HISTORIC PRESERVATION REVIEW BOARD STAFF REPORT AND RECOMMENDATION

Property Address: 1201-1219 Massachusetts Ave NW X Agenda

Landmark/District: Church of the Ascension and St. Agnes Consent Calendar

The Church of the Ascension and St. Agnes and DAKS Development seek conceptual design review for construction of a seven-story residential building and alterations to a side chapel/social hall for construction of a new parish hall.

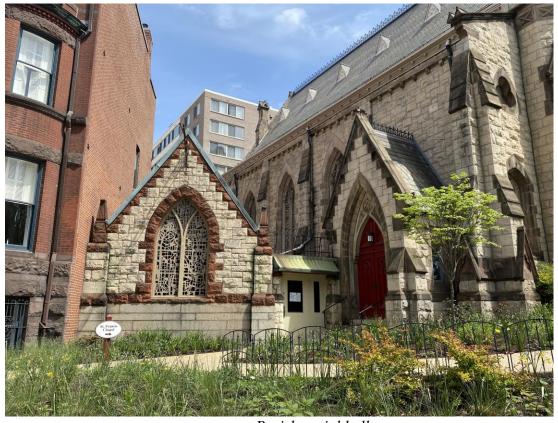
Option 2 for the parish hall is certainly the better preservation approach. While more challenging in terms of how it connects to the church and its double-height windows, this option reads as more subordinate to the landmark church, retains the public visibility of the west façade as experienced from street view, and results in a better proportional relationship to the retained portion of the parish hall. This option would not preclude having a roof terrace as shown in the first option, which could still be achieved with a lower wall or railing pulled back from the new front wall.

HPO recommends that the Board find the proposed concept for a seven-story building behind 1217 and 1219 Massachusetts Avenue to be compatible in height and mass with the Shaw Historic District and option 2 for the parish hall to be generally compatible with the landmark, and that the project continue to be developed and return for further design review when ready.
